MINERALS PROGRAM INSPECTION REPORT
PHONE: (303) 866-3567

MINE NAME: Lyons Quarry	MINE/PROSPECTING ID#: M-1977-141	MINERAL: Quartz (quartzite/quartzose ss)	COUNTY: Boulder
INSPECTION TYPE: Monitoring	INSPECTOR(S): Amy Eschberger	INSP. DATE: June 3, 2020	INSP. TIME: 10:00
OPERATOR: Aggregate Industries - WCR, Inc.	OPERATOR REPRESENTATIVE: Jeremy Deuto	TYPE OF OPERATION: 112c - Construction Regular Operation

This was a normal monitoring inspection of the Lyons Quarry (Permit No. M-1977-141) conducted by Amy Eschberger of the Division of Reclamation, Mining and Safety (Division). The operator was represented by Jeremy Deuto during the inspection. Justin Atherton-Wood and David Hirt of Boulder County Parks and Open Space were also present during the inspection. The site is located approximately 2.5 miles southwest of Lyons, CO in Boulder County. The site is situated just south of South Saint Vrain Creek and Hwy 7. The site can be accessed by turning south/southeast off Hwy 7 (approximately 1/2 mile southwest of the Hall Ranch Trailhead), crossing the new steel truss bridge constructed over the creek, and heading south/southwest down Old St Vrain Rd through a gated entrance. The affect

EXHIBIT F
RECLAMATION PLAN
PREPARED MAY 10, 2017

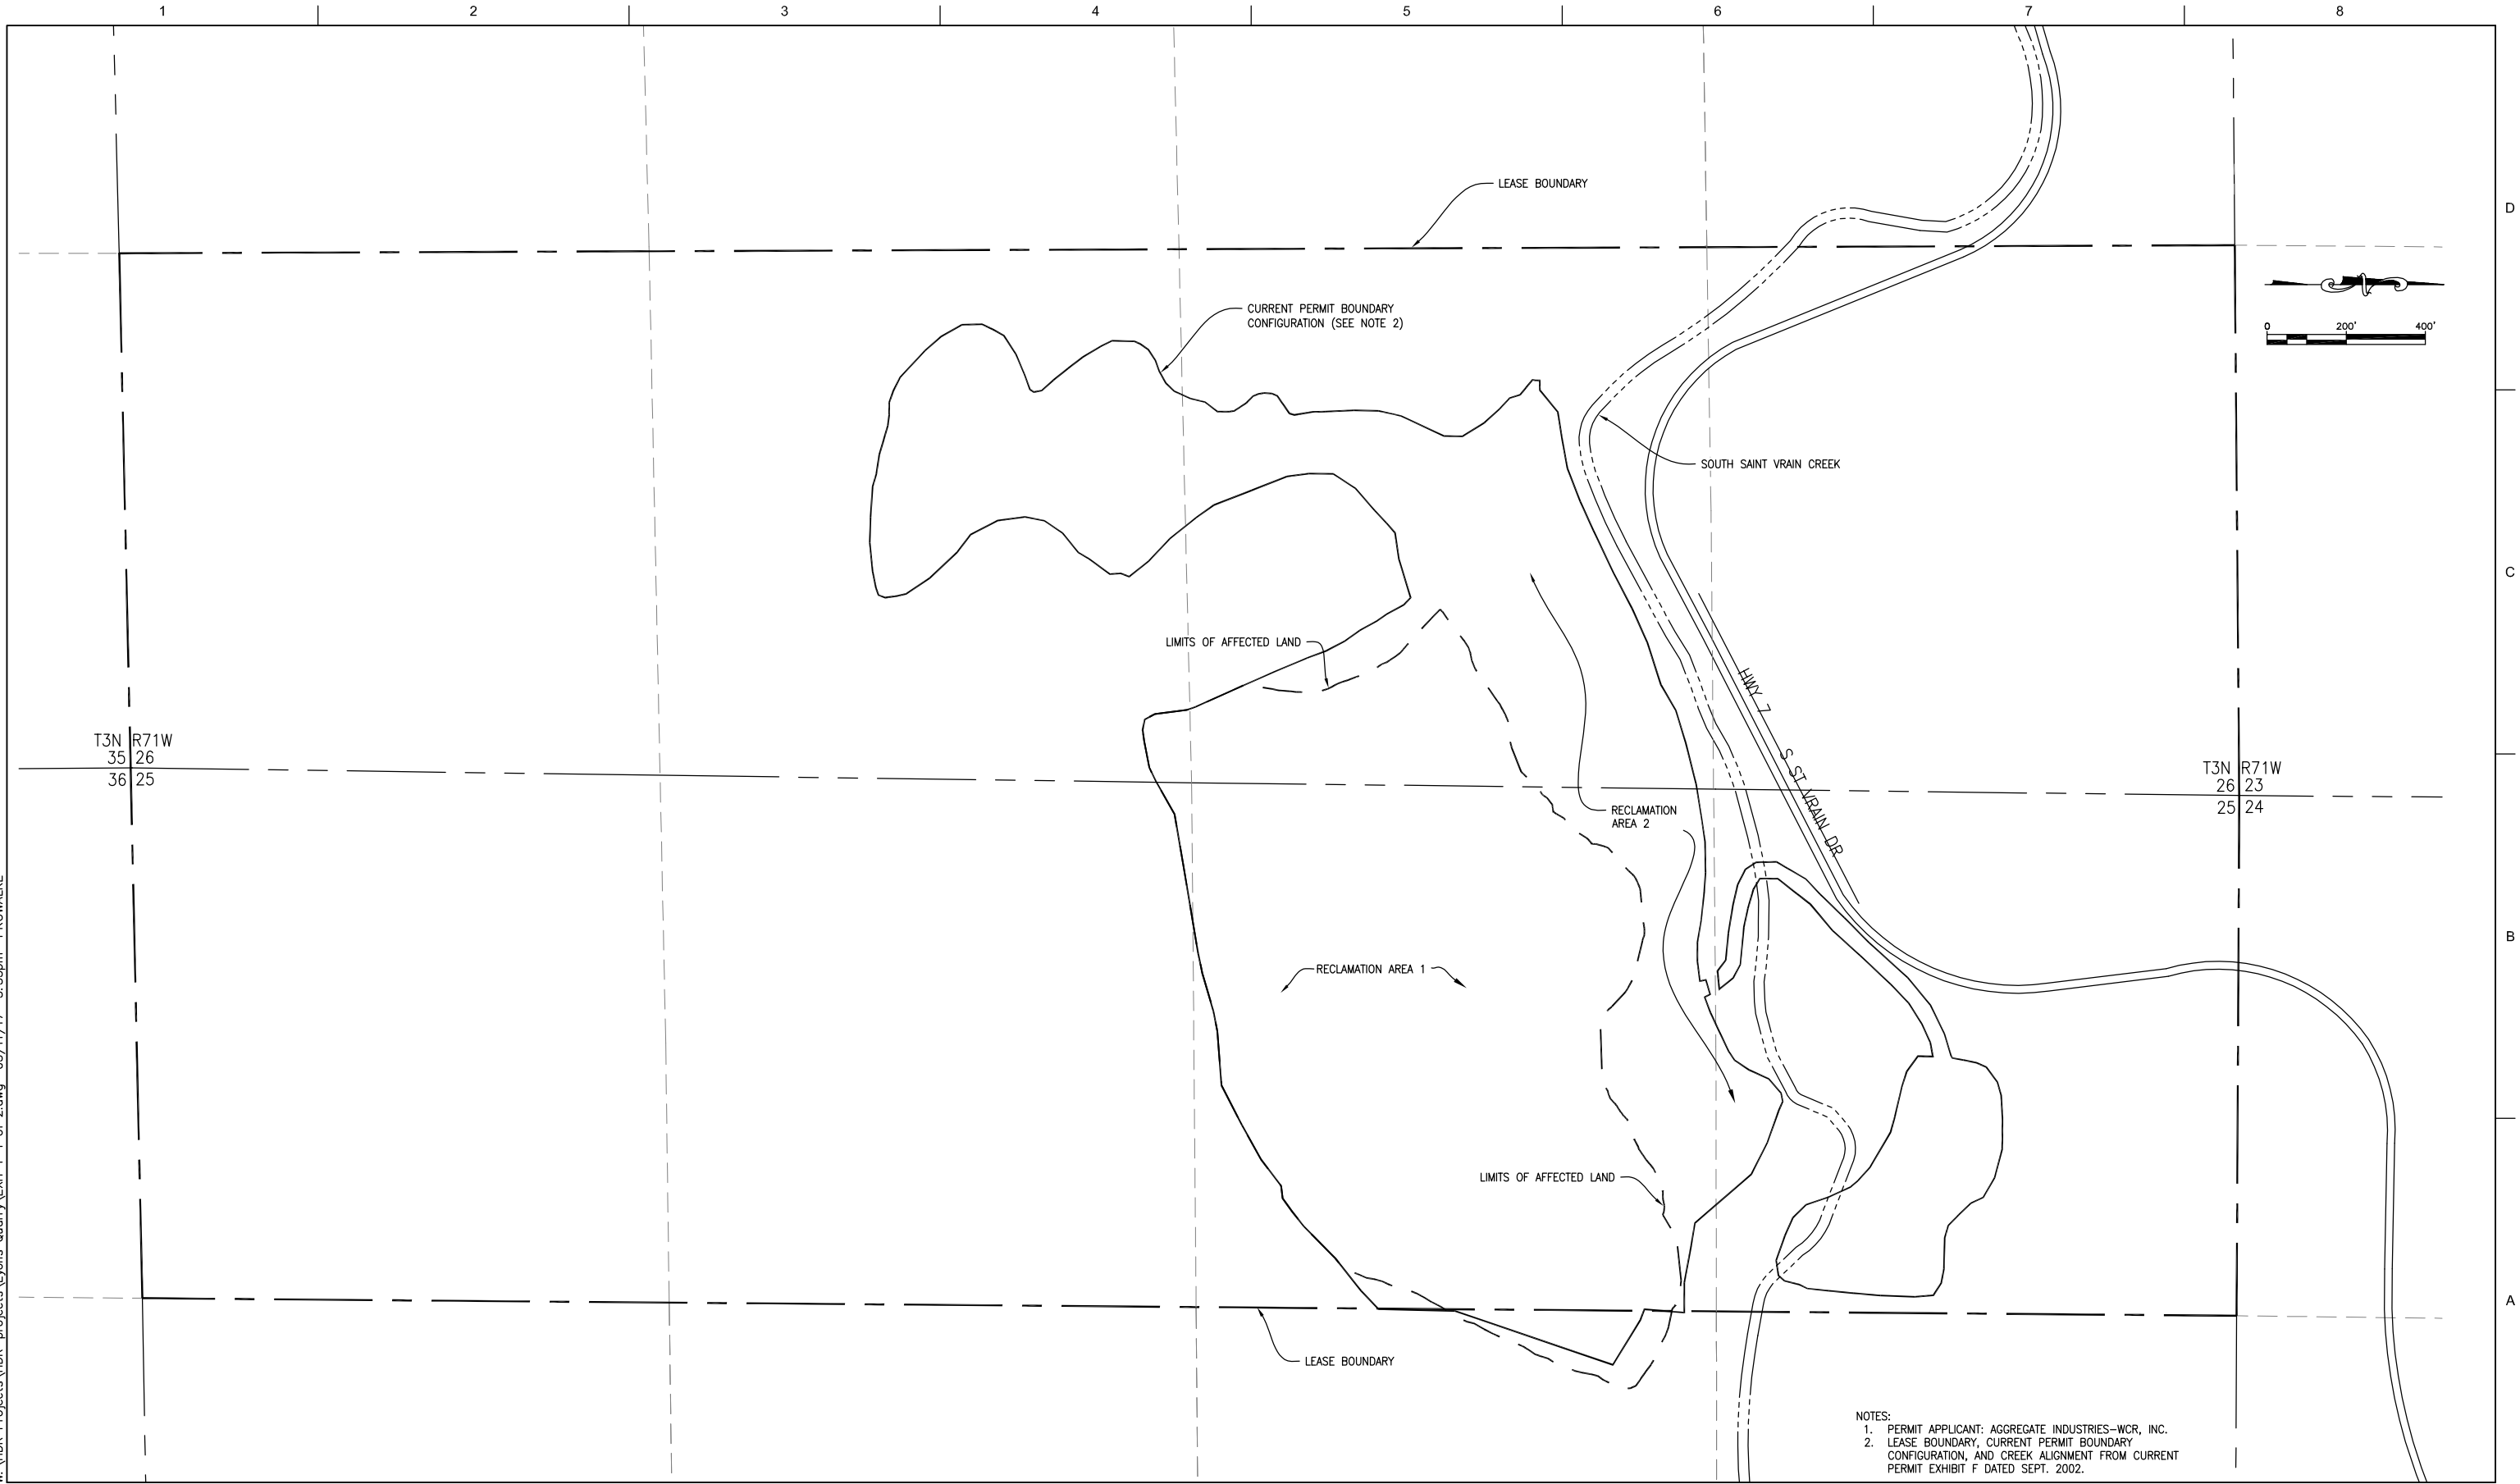
PROBLEM #3: The current reclamation plan needs to be updated and clarified pursuant to C.R.S. 34-32.5-116. The operator must provide sufficient information to describe or identify how the operator intends to conduct reclamation. Specifically, the reclamation plan needs to be updated to describe how the area designated (in TR-2) as Reclamation Area 2 will be reclaimed. The reclamation plan map must also be revised accordingly.

TR-2 only addressed reclamation of the pit area, designated as Reclamation Area 1. It did not address reclamation of the former processing/stockpiling/storage area, designated as Reclamation Area 2, which was impacted by the September 2013 flooding. However, the operator committed to developing a new reclamation plan for Reclamation Area 2 in coordination with Boulder County and submitting this plan in a subsequent Technical Revision.

CORRECTIVE ACTIONS: By the corrective action date, the operator shall submit a Technical Revision, with the required \$216 fee, to update and clarify the current approved reclamation plan to reflect existing and proposed activities. Specifically, the reclamation plan must be updated to describe how the area designated (in TR-2) as Reclamation Area 2 will be reclaimed. Additionally, the revision must include an updated reclamation plan map that meets the requirements of Rules 6.2.1(2) and 6.4.6.
